Responses to Comments on the Application for Clean Water Act Section 404 and 401 Permit **SOUTHEAST CONNECTOR**

SPK-2010-01058

February 21, 2014

Response to U.S. Army Corps of Engineers Comments on the Application for Clean Water Act Section 404 and 401 Permit, SouthEast Connector

FIGURE 1
Geometry of Soil Placement

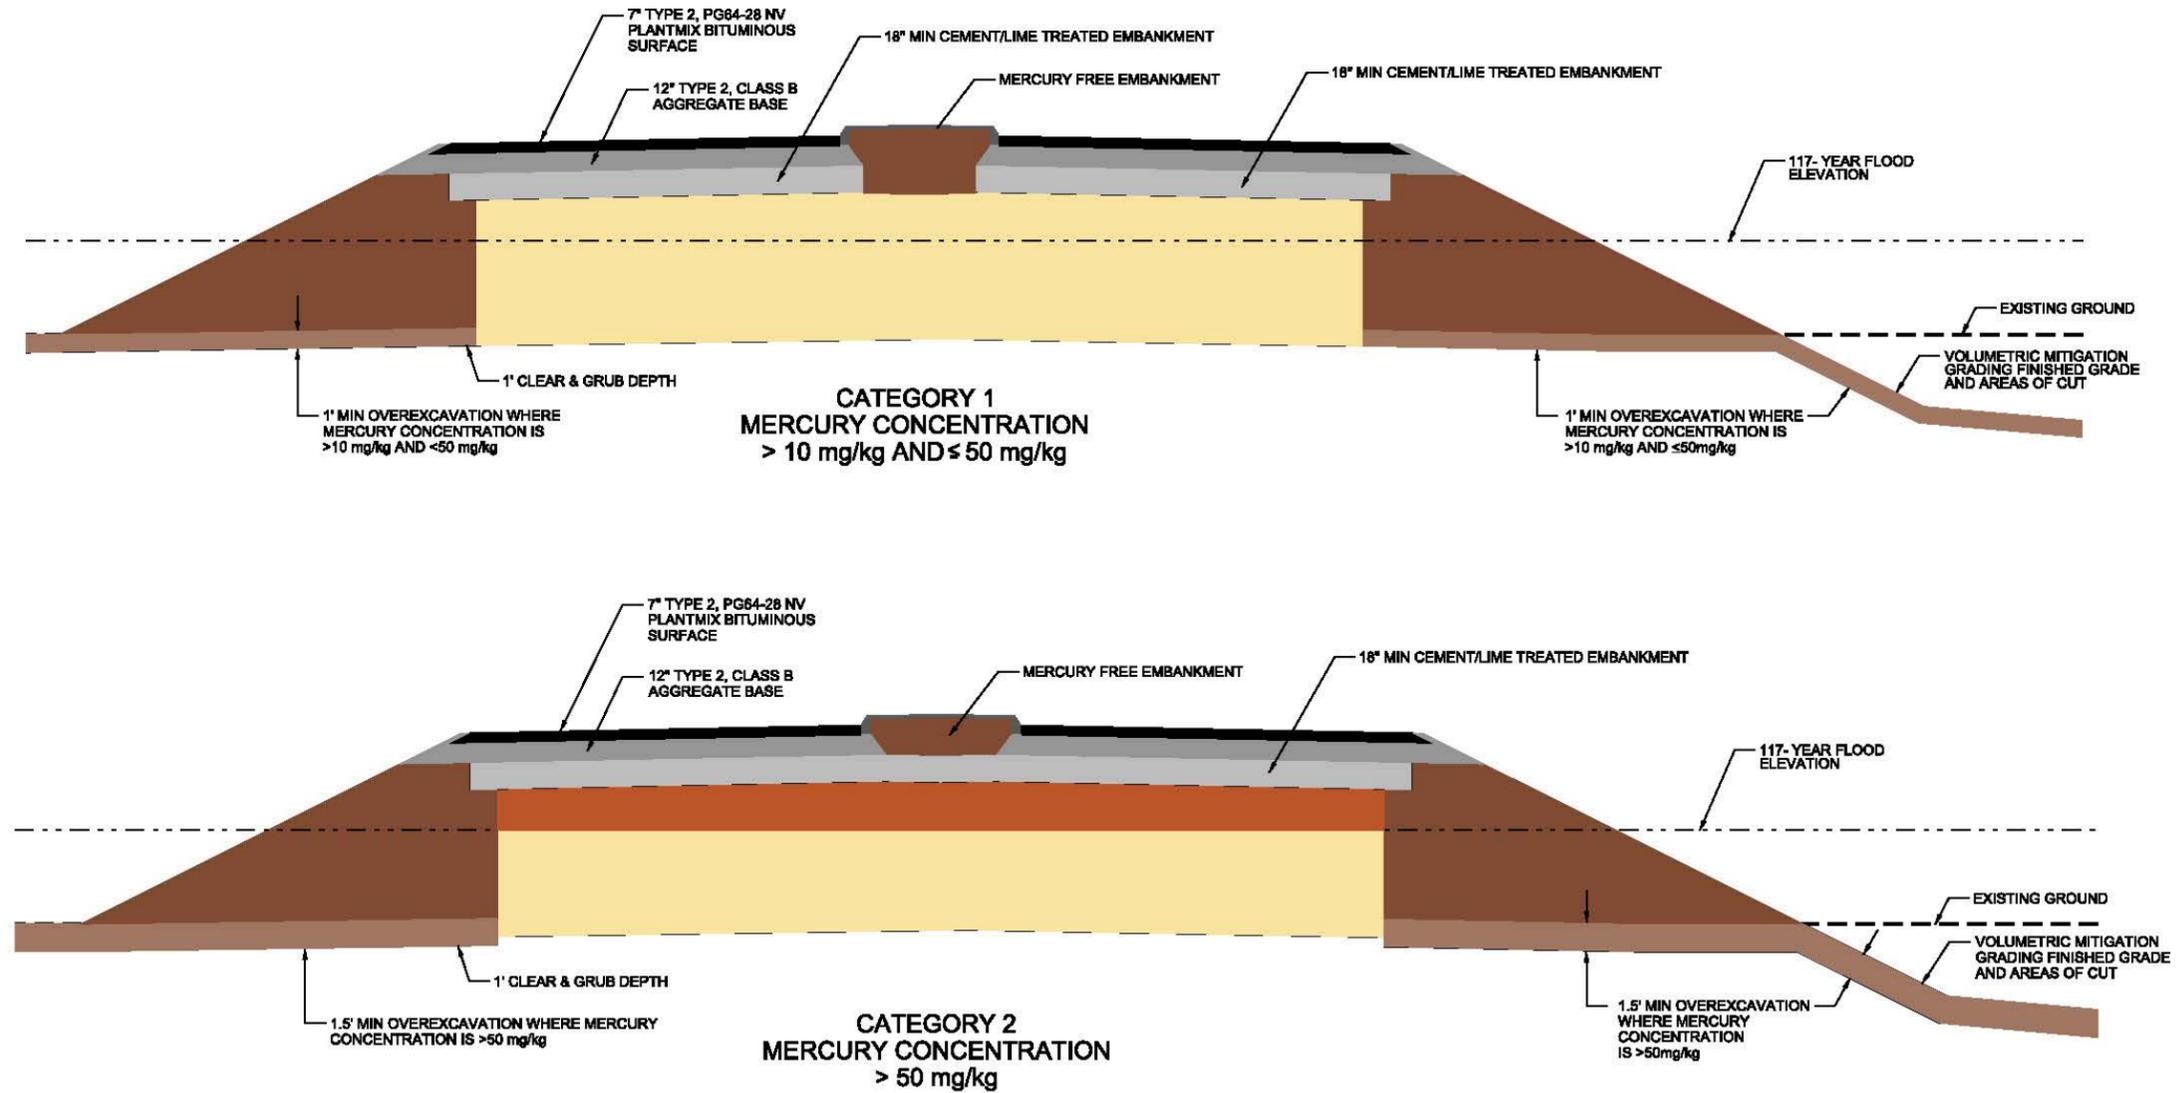
Please provide a discussion of how it is appropriate to dispose of contaminated fill within a raised roadbed in a floodway and how erosion of the roadbed to the contaminated material will be prevented.

Response: *The approach to sequester mercury-containing materials beneath the roadway is more protective than U.S. EPA's clean-up activities at the Carson River Mercury Site, which is part of the Comstock Mining District and the source of mercury-containing soil throughout the Steamboat Creek system. At U.S. EPA's Carson River Mercury Site, residential properties containing >80 mg/kg total mercury in surface soil were 1) excavated to a depth of 2 feet and capped/covered with clean, imported soil; or 2) 2 feet of clean, imported soil was placed over mercury-containing soil. Both approaches were determined to reduce the risk to residential receptors to acceptable levels. A similar approach was taken for U.S. EPA's Sulfur Bank Mercury Mine Site near Clear Lake in Lake County, California.*

At the project site, an appropriate standard of care is being taken and soil containing 10 mg/kg or more total mercury that requires excavation will be placed within the embankment beneath and inside the edge of the pavement surface. Soil containing relatively higher mercury (e.g., 50 mg/kg or more) will be placed above the 117-year flood elevation between South Meadows Parkway and Mira Loma Drive. Median drains will be placed throughout the roadway corridor to prevent storm water infiltration. An 18-inch-thick cement-lime-treated lens will be placed immediately beneath the roadway's aggregate base where the relatively higher mercury-containing soil is placed to prevent erosion and leachability of these materials to the environment. The project will result in the permanent removal of >8,500 kg (>18,000 pounds) of mercury from the environment of the Steamboat Creek system, to be sequestered in the embankment. Simplified diagrams that illustrate the geometry of soil placement beneath and inside the edge of the pavement surface above and below the 117-year flood elevations are shown in Figure 1.

The stability of the roadbed has been analyzed by the geotechnical and hydraulic design teams. In areas of high velocity, appropriate riprap placement is provided to armor against erosion as mandated in the civil design standards of the project. The cement-lime encapsulation of material has been engineered to reduce the permeability of the material to eliminate the potential for saturation and transport of material from the soil-cement-lime matrix. In addition, the roadway embankment is capped with 2 feet of clean fill material that is vegetated to further reduce the likelihood for erosion. The standard for roadway maintenance within the city of Reno and Sparks is to address areas of erosion for the protection of the roadway integrity. This same practice will also identify and address areas of erosion should they occur before the erosion would ever penetrate the portion of the embankment that contains mercury soils.
